Access Compliance Report

Public Rights-of-Way

(Curb Ramps)

Intersection ID: 44540	Main Street: NEAL_RD	Cross Street: UNIVERSITY_CITY_BV	Location: W
ADA ID: CEF15955383D	Ramp Type: BlendTrans1	Initial Pass/Fail: Fail	Overall Compliance: No
Severity Score: 8.75			
Codes/Mitigation Info/Possible Solution		Field Measurements/Component Compliance

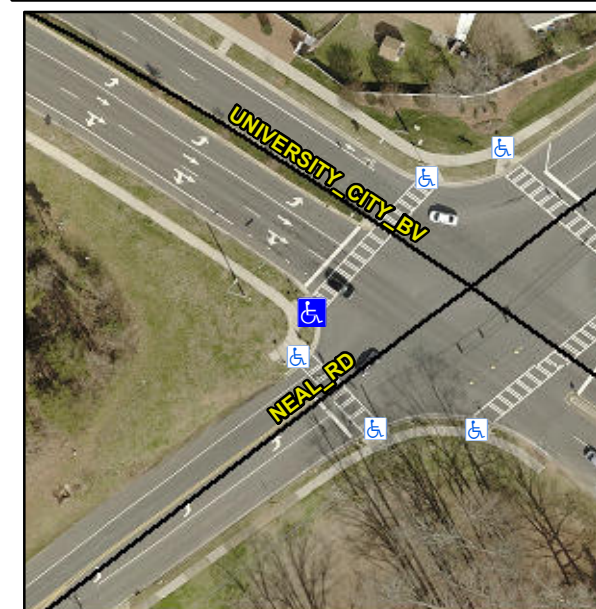
Not Found, R304.5.1

Compliance	Description	Data	Compliance	Description	Data
N/A	Ramp Length (in)	96.0	Yes	BlendTrans Slope (%)	4.2
No	Ramp Width (in)	46.5	Yes	BlendTrans XSlope (%)	1.7
N/A	Flare Type LT	N/A	N/A	Flare Type RT	N/A
N/A	Flare Slope LT (%)	N/A	N/A	Flare Slope RT (%)	N/A
N/A	Flare Traversable LT?	N/A	N/A	Flare Traversable RT?	N/A
N/A	Landing Length (in)	N/A	N/A	DWS Provided?	N/A
N/A	Landing Width (in)	N/A	N/A	DWS Contrast?	N/A
N/A	Landing Slope (%)	N/A	N/A	DWS Length (in)	N/A
N/A	Landing X Slope (%)	N/A	N/A	DWS Full Width?	N/A
N/A	Landing Curb? (Y/N)	N/A	N/A	DWS Offset (in)	N/A
N/A	Shared Landing?	N/A			
N/A	Gutter Ponding?	N/A	N/A	Gutter Slope (%)	N/A
N/A	Gutter Lip Ht (in)	N/A	N/A	Gutter X Slope (%)	N/A
N/A	Painted X Walk1?	Yes	N/A	Painted X Walk2?	N/A
	X Walk 1 Direction	To NE		X Walk 2 Direction	N/A
	X Walk 1 Width (in)	104.0		X Walk 2 Width (in)	N/A
	X Walk 1 Slope (%)	1.9		X Walk 2 Slope (%)	N/A
	X Walk 1 X Slope (%)	0.5		X Walk 2 X Slope (%)	N/A

N/A	Ramp inside XWalk1?	Yes	N/A	Ramp inside XWalk2?	N/A
	Road Slope (%)	0.5		Clear Space?	N/A
	Road X Slope (%)	1.9	N/A	Clear Space to XWalk (in)	N/A
N/A	Any Obstructions?	N/A	N/A	Storm Grate/Utility Hazard?	N/A
	Obstruction Type			Storm Grate/Utility Type	
		N/A			N/A
			Yes	Surface Condition? (G/P)	Good
			No	Curb Slope (%)	10.8

Remove & Replace Curb Ramp With Two New Directional Ramps or Equivalent.
